Planning Commission Issues and Vote Report

Petition: **P.Z. 16-2017 Chesterfield Village Mall (Shelbourne Senior Living)**: A request for a zoning map amendment from a “C8” Planned Commercial District to a new “UC” Urban Core District for an 8.2 acre tract of land located southeast of the intersection of Chesterfield Parkway West and Chesterfield Center (18S110148).

**Re: P.Z. 16-2017 Chesterfield Village Mall (Shelbourne Senior Living) –
Rezoning – First Issues Letter Response**

SKY PLANE EXPOSURE

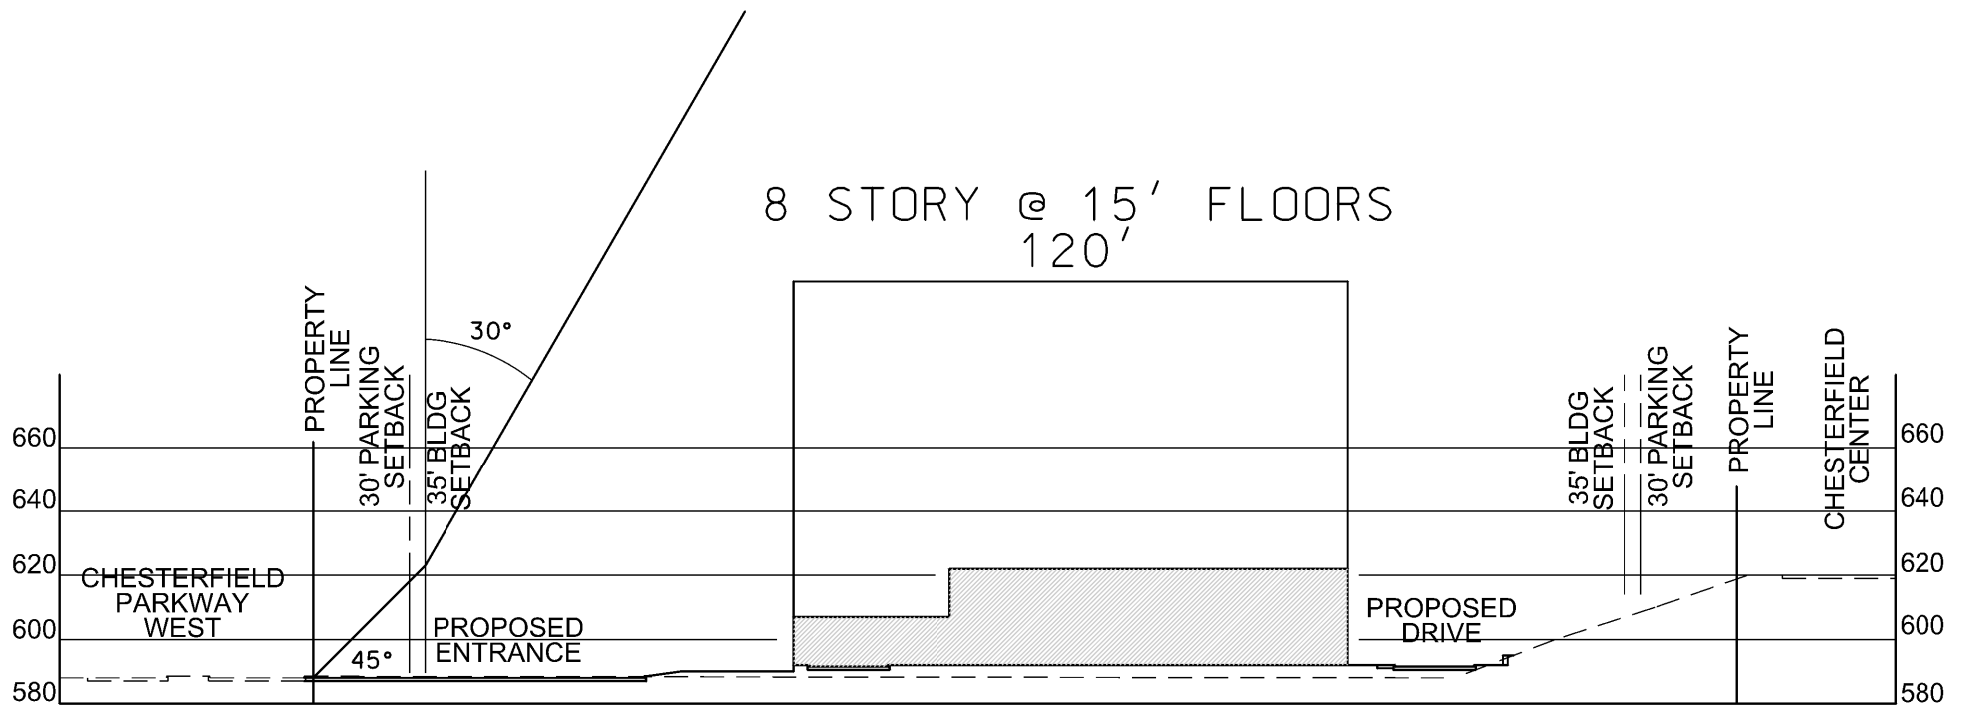
3. Sky Exposure Plane. Circumvent a tunneling effect along Chesterfield Parkway West by avoiding an acute angle of buildable area in relation to the front yard setback. In order to achieve this, provide the Sky Exposure Plane on the section profiles.

Response: See the enclosed "Sky Plane Exposure" exhibit. Applicant notes that issues regarding sky plane exposure are generally addressed during the Site Development Plan phase. However, Applicant is willing to provide the requested exhibit to show that Applicant's proposed development is well within the City's requirements.

Please find one (1) copy of the "Sky Plan Exposure" exhibit enclosed for your review.

PRELIMINARY DEVELOPMENT PLAN
BASE MAP NO. 18S
LOCATOR NO. 18S10148
VOLZ NO. 21462
H:\cadd\21400-21499\21462\Planning\Preliminary\PDP SHEET 2017.dgn

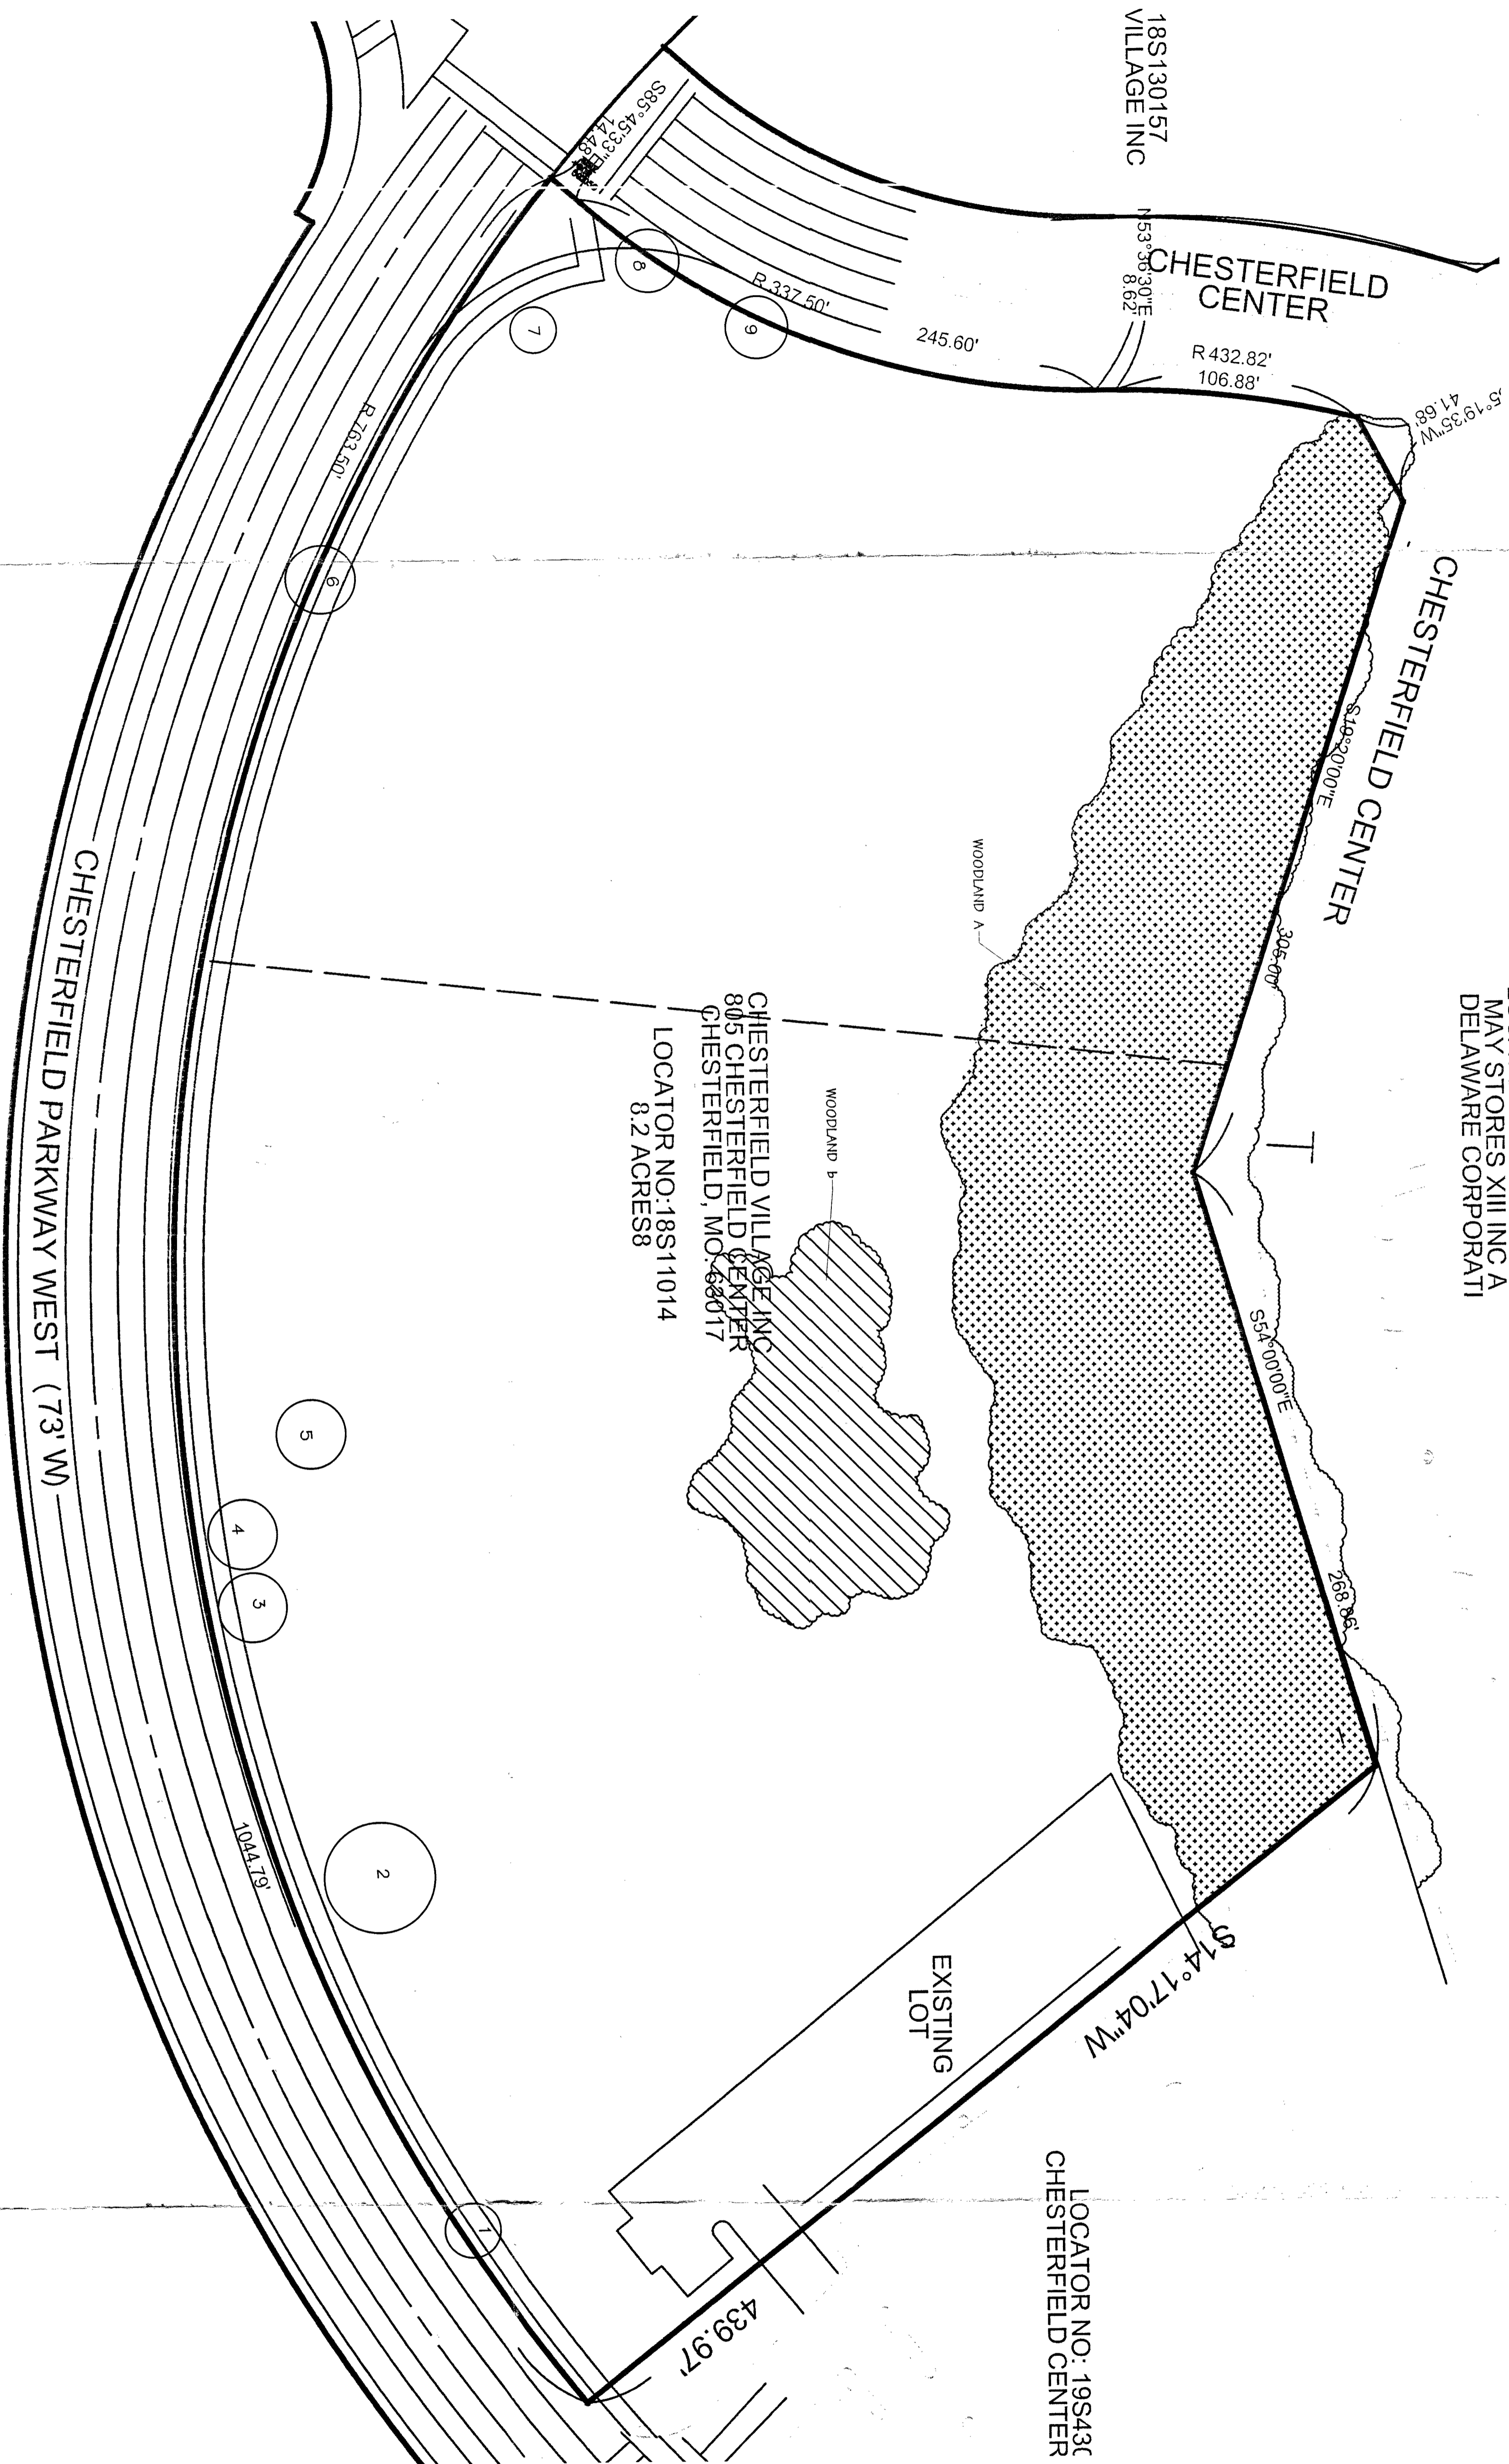
5. Preliminary Plan Comments. Show existing and proposed cross access easements.

6. Preliminary Plan Comments. If cut or fill slopes in excess of the standard maximum of 3:1 horizontal run to vertical rise are desired, approval for the steeper slopes must be obtained from the City of Chesterfield. Review of the proposed steep slope(s) will be concurrent with the review of the Site Development and/or Improvement Plans or the Grading Permit for the project. On the Preliminary Plan, any proposed slope in excess of 3:1 should be labeled and referenced with the following note: Approval of this plan does not constitute approval of slopes in excess of 3:1. Steep slopes are subject to the review and approval of the City of Chesterfield.

Response: A revised Preliminary Development Plan will be provided to show the cross-access easement with the property to the South of the subject site.

Response: Acknowledged. If necessary, this will be addressed during the Site Development Plan phase.
